VALUE ENGINEERING STUDY

Project # STP00-1004-00(002) PI No. 631260-

EXTENSION OF SR 382 FROM CR 239 TO SR 5/515 Gilmer County, Georgia

17 November 2011

EW-2.1 - PROPOSED PROFILE
1 OF 2

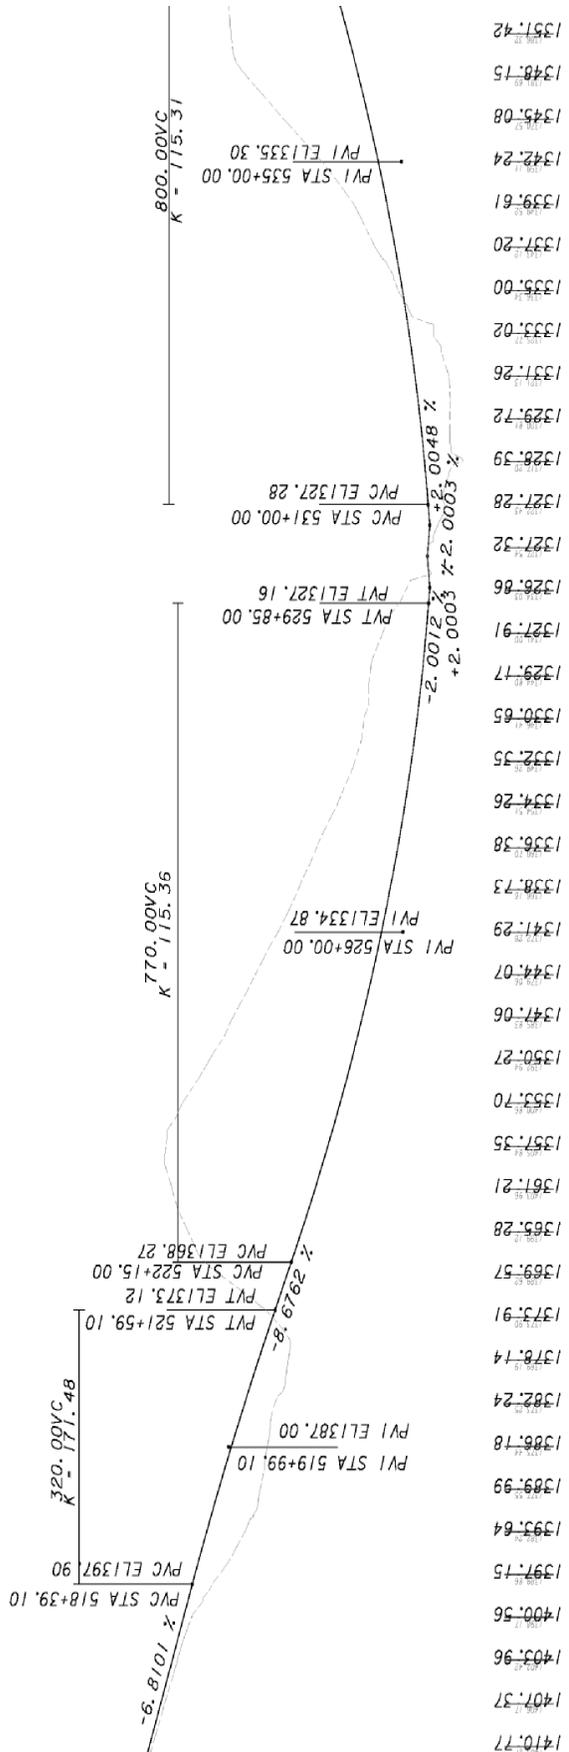
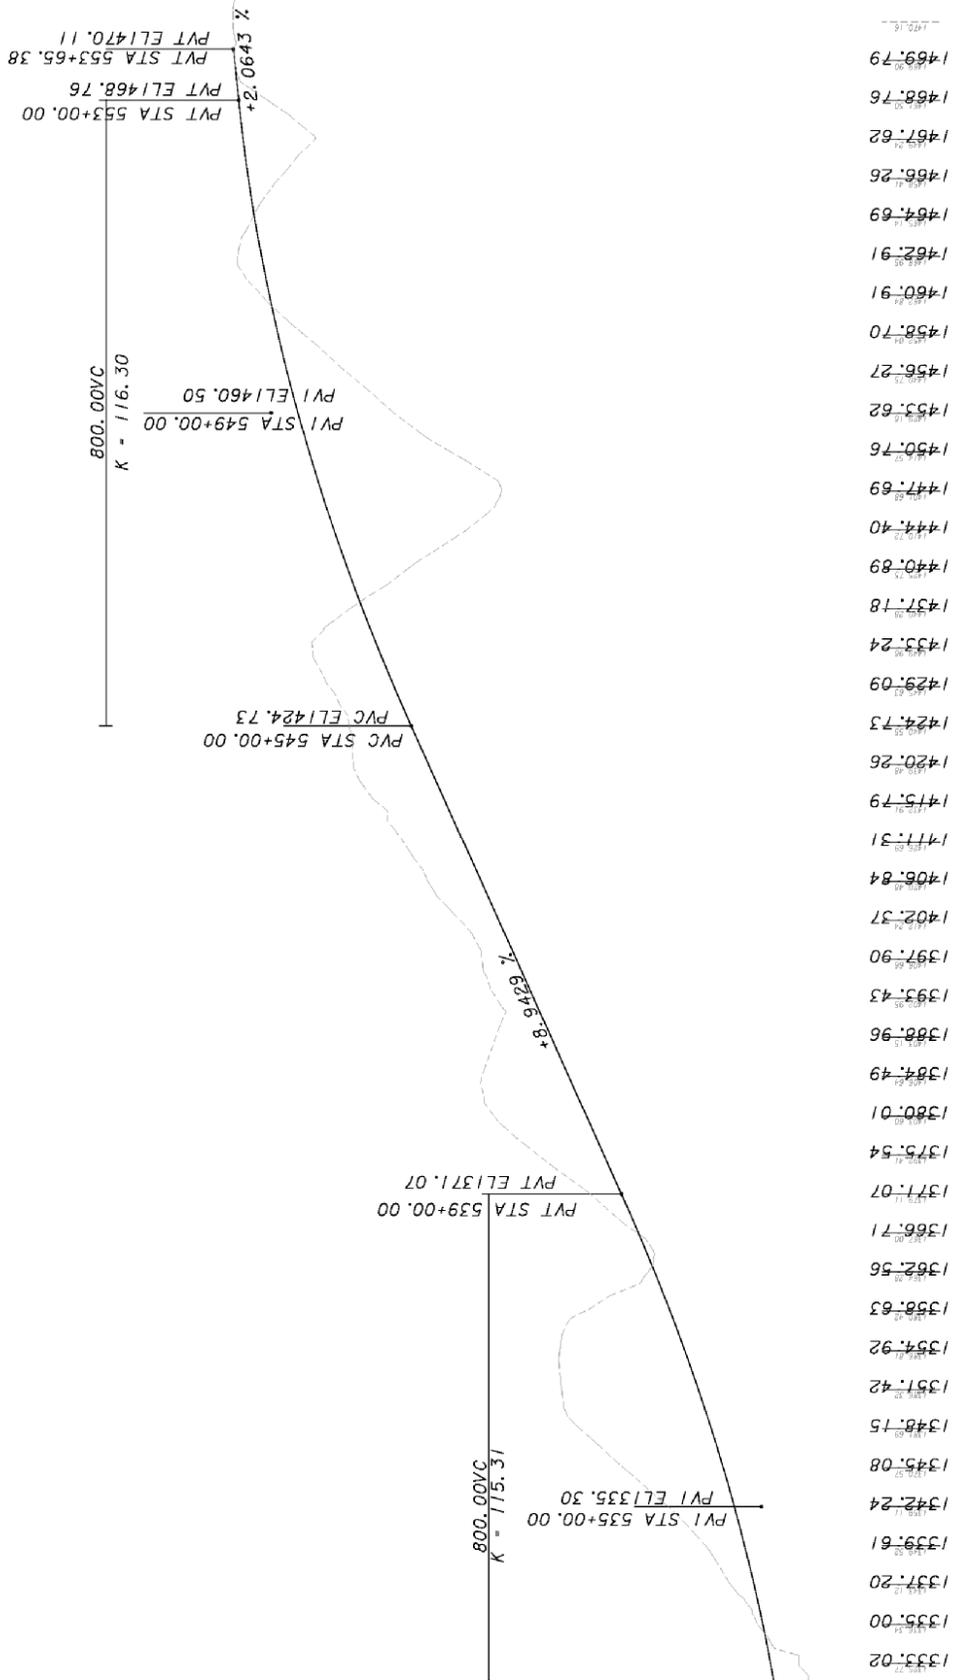
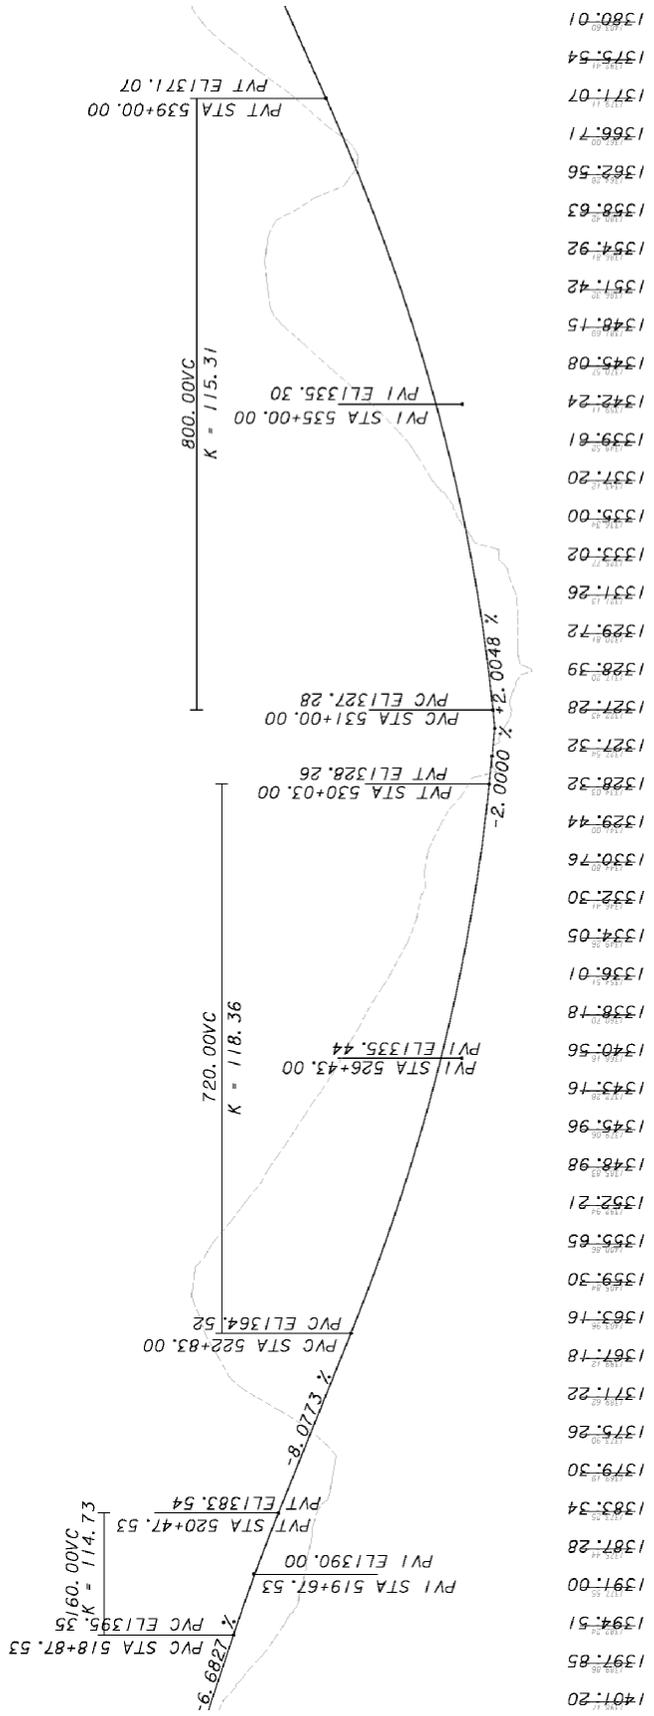
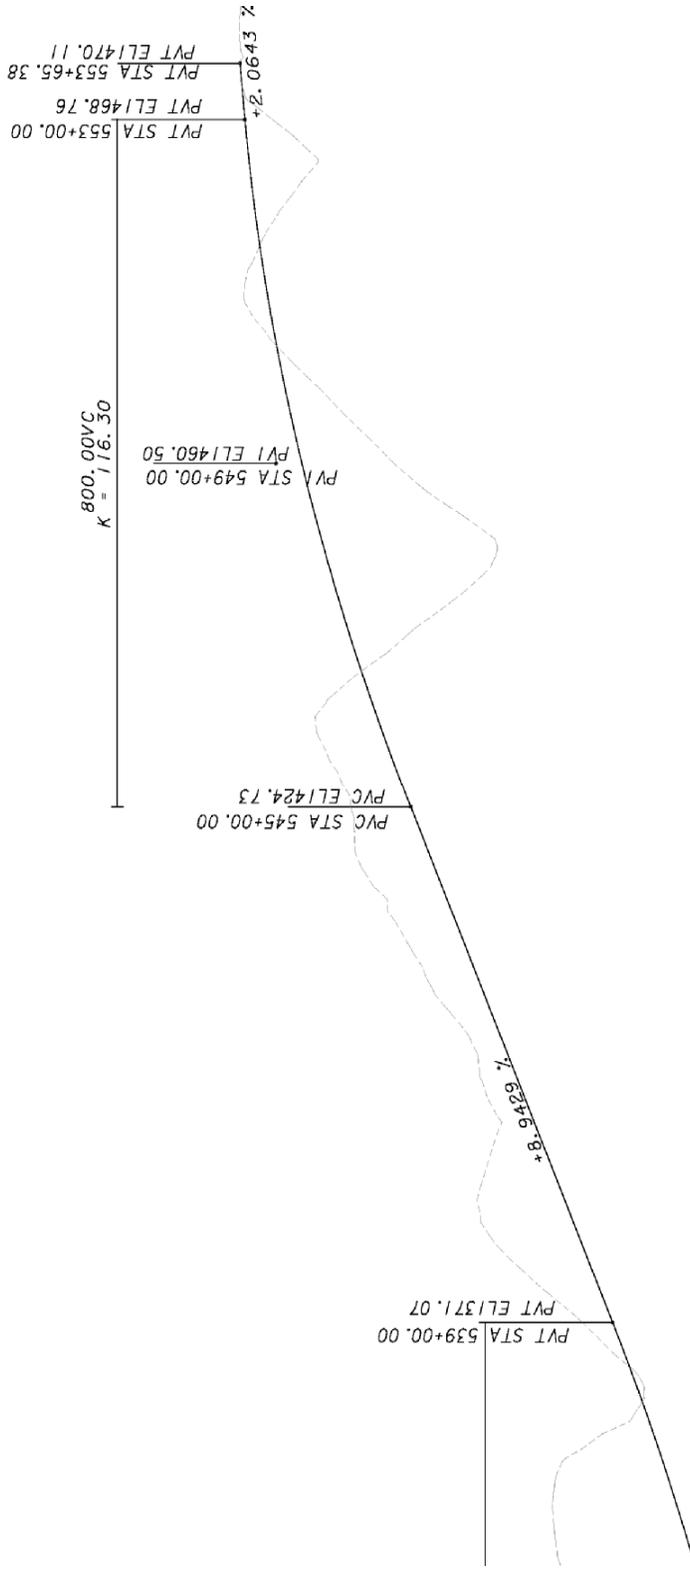
PROPOSAL DESCRIPTION: REVISE SR 382 & SR 382 EXTENSION PROFILE TO REDUCE EARTHWORK AND ROW IMPACTS.

ORIGINAL DESIGN: The original design proposes a roadway profile that results in significant earthwork and right-of-way impacts on SR 382 and SR 382 Extension.

PROPOSED CHANGE: The proposed change proposes a roadway profile that reduces the quantity of required earthwork and amount of right-of-way impacts on SR 382 and SR 382 Extension. The proposed speed design for the roadway profile will be changed from 55 mph to 45 mph.

JUSTIFICATION: The original design proposes a profile that produces significant excavation on SR 382 and SR 382 Extension. These two roads are at a stop condition at the intersection with CR 239/SR 382. The proposed change proposes a reduction of speed design to 45 mph due to the stop condition and the results of the traffic study which show that a signal is not warranted. The revisions to the profile generate significant cost savings in earthwork and right-of-way.

PROPOSAL NUMBER: EW-6.0

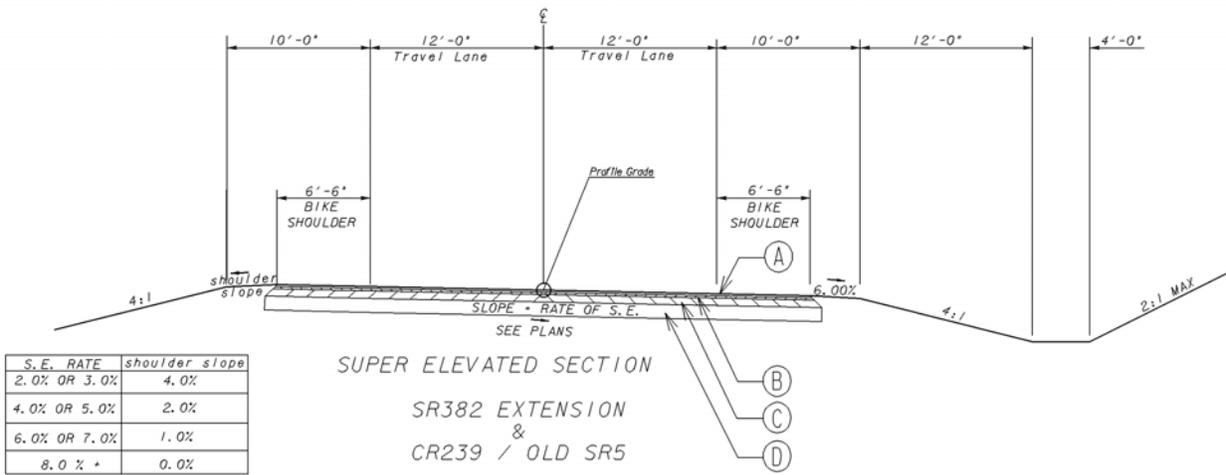
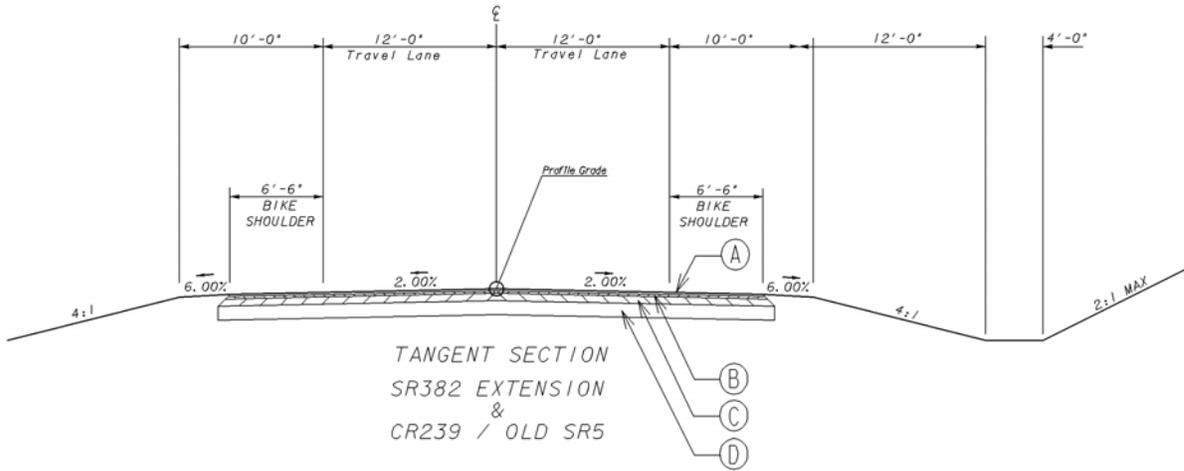
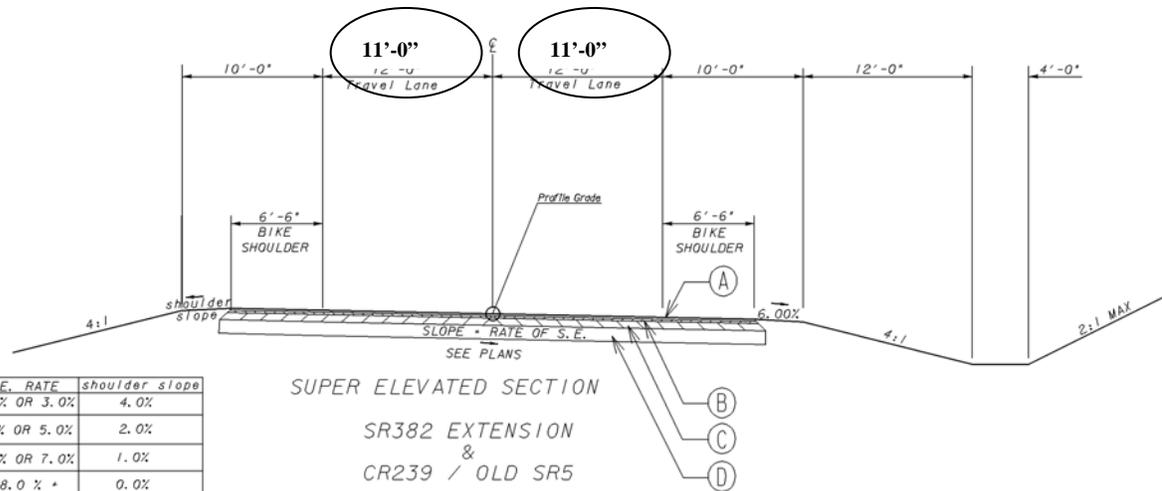
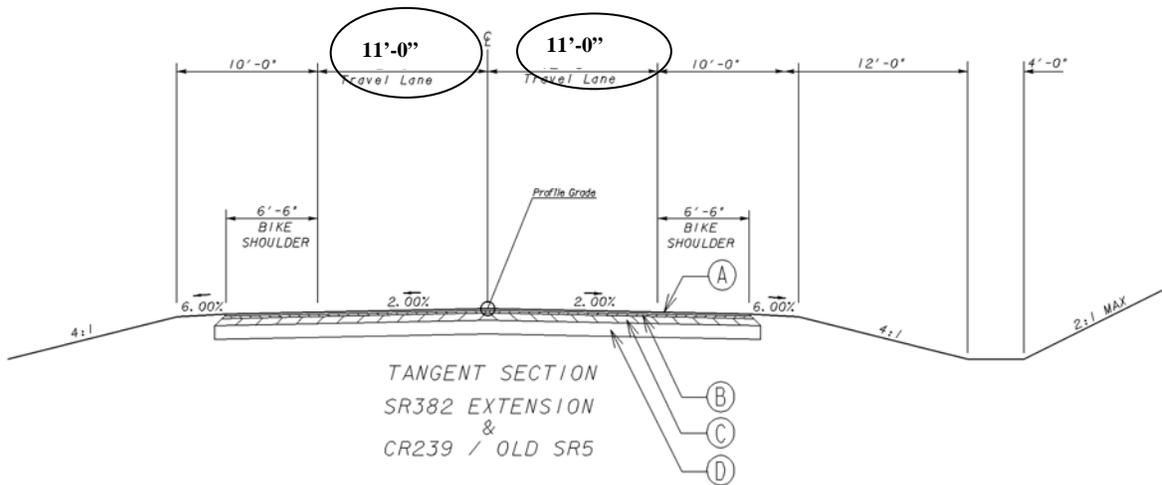
PROPOSED CHANGE: The proposed recommendation is to install 11 foot wide travel lanes.

JUSTIFICATION: The original design proposes a standard 12 foot width lane throughout the project. The function of the travel lanes is to convey traffic, and this function can be accomplished through a reduced width travel lane. The proposed alignment through the new location sections requires significant excavation and embankment due to hilly terrain. The proposed change is adequate for a 50 mph corridor and will result in significant savings in earthwork and pavement.

PROPOSAL NUMBER: PV-2.0

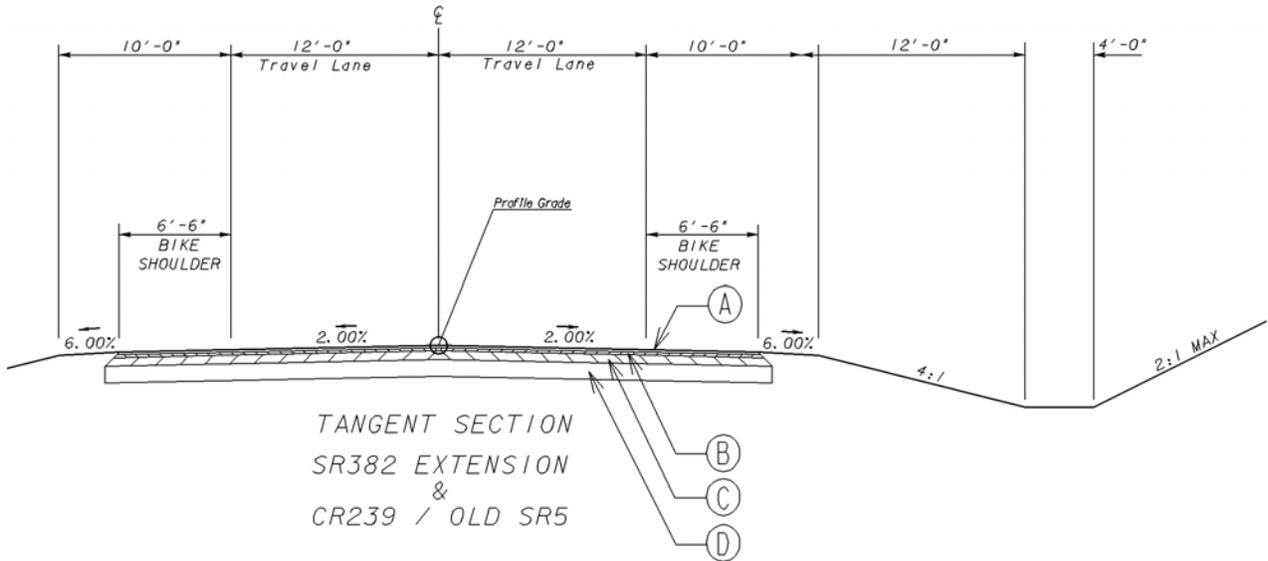
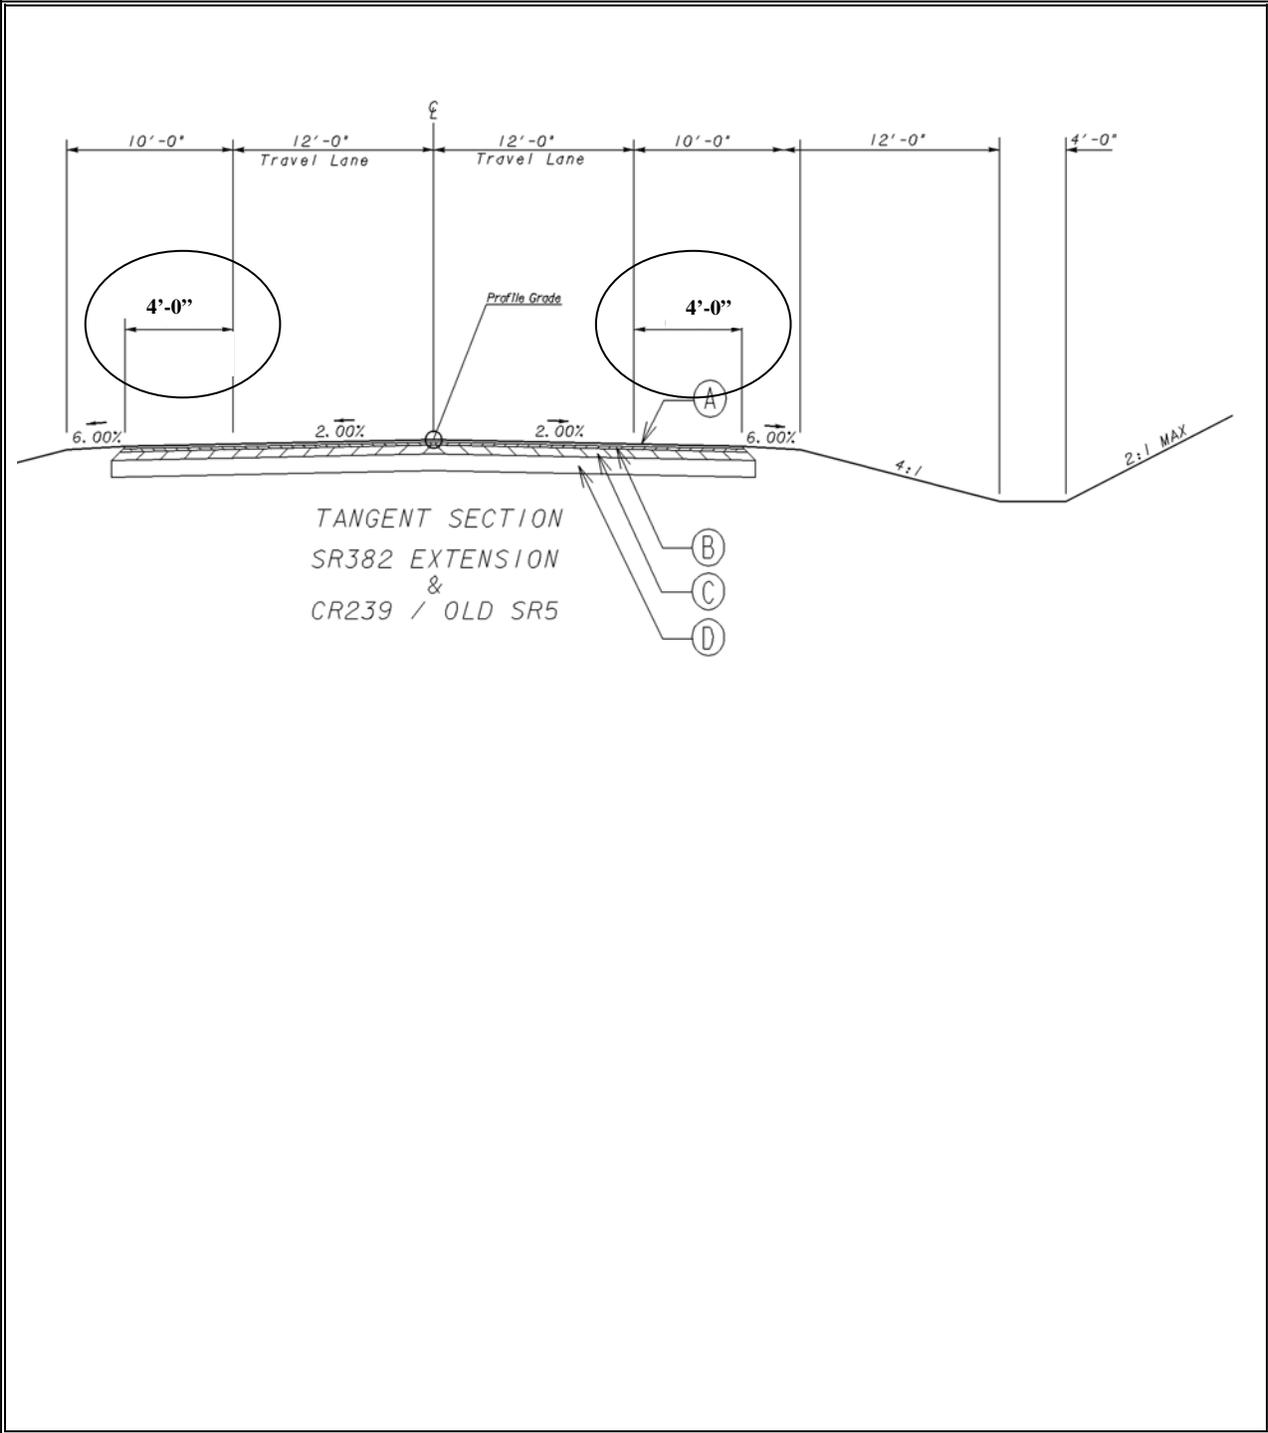
PROPOSED CHANGE: The proposed change proposes to install a 4 foot wide paved shoulder on the SR 382 extension and CR 239. It was discovered that this route was not a designated bike route.
